SUSQUEHANNA STEAM ELECTRIC STATION

INVESTIGATION OF UNIT ONE

SMALL PIPING SYSTEM DESIGN

PROGRAM ADEQUACY AND IMPLEMENTATION

SUBJECT SP-HBC-78-7 & SP-HBC-78-8 SHEET NO. 3

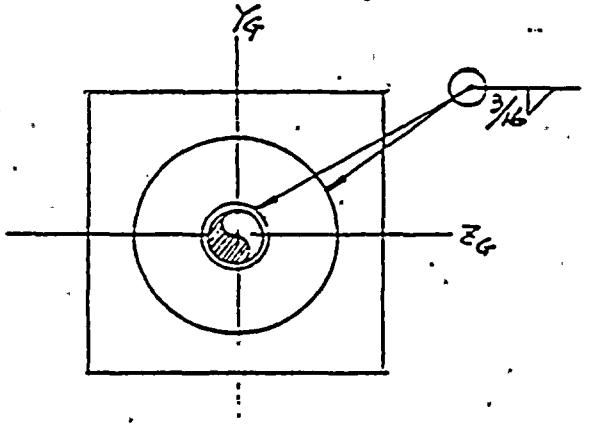
THE MAJOR DIFFERENCE BETWEEN THE AS-BUILT HANGER & SPA 720 IS THAT THE AS-BUILT USES A SMALLER & THINNER Æ THAN THE SPA. PRELIMINARY CALCS. USING THE ORIGINAL LOADS SHOW THAT THE SUPPORT WOULD FAIL, THUS THE FOLLOWING LESS CONSERVATIVE LOADS WERE GIVEN BY STRESS.

FIGURE A-3.15

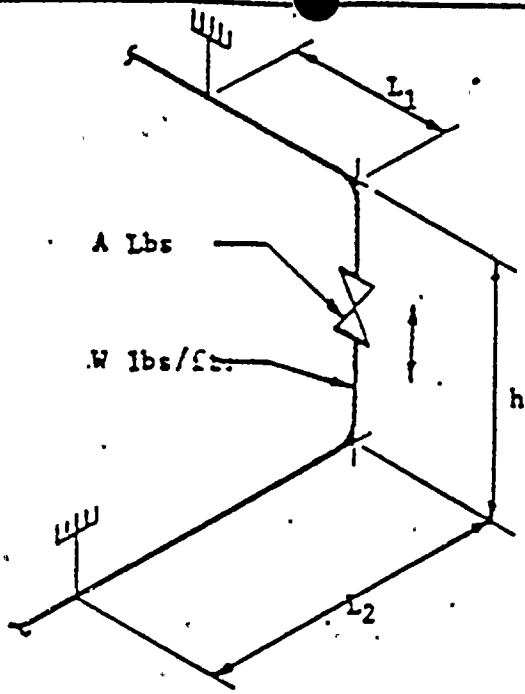
Specification 8856-M-241 (Rev. 3) Appendix A figure A-3.15 presents geometry adjustment factors for concentrated weights and dynamic loads for one piping geometry. As the figure is self explanatory, no additional instructions are provided for its use. The figure states, "F W/WL = 0.51 to 1.0 ... Multiply maximum span L by F= 0.33."

Contrary to this, calculation #5268 (Rev. 2), sheet 4, span "H2000 to H2011" shows for W/WL = 0.78 ... multiplication of maximum span L by F = 0.42. Investigation indicates that this value of F was obtained by interpolation of the values for F given in figure A-3.15. Such

interpolation of the values for F presented in Figure A-3.15 are not authorized within the specification. Application of this larger value for F, obtained by interpolation, resulted in acceptance of a 2'-5½" span, which should have been identified as being 4½" overlength, by spec M-241 criteria.

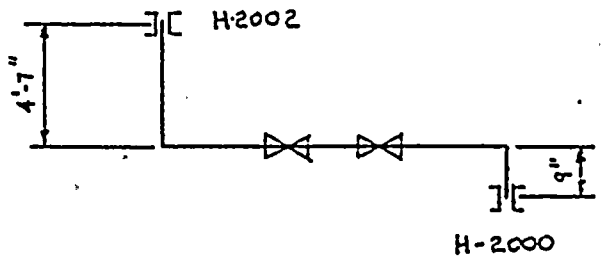
Calculation #5268 - Isometric SP-HCB-109-1, Rev. 14; SP-HCB-109-2, Rev. 16. Sheet #5 of the above calculation shows the required span length between H2000 and H2002. Engineering judgement was used in the distribution of load between the two supports. (See attached for details). The same type of assumption was applied to the span calculation between penetration X-221A and H2011. Spec. M-241, Rev. 3 does not indicate any tolerances can be applied to the above condition.

The span between H2000 and H2002 can be represented as shown below.

The calculations indicate that all of the dynamic loads associated with the concentrated pipe and valve weights is taken by H2000. Strict interpretation of Spec. M-241, Rev. 3 would indicate that the load should be split up between the both supports and the span adjusted accordingly.

Spec. M-241, Rev. 4 provides direction for this type of condition, that is, when all the load can be lumped on one support and not split up. The calculations noted above appear to go beyond these guidelines also.
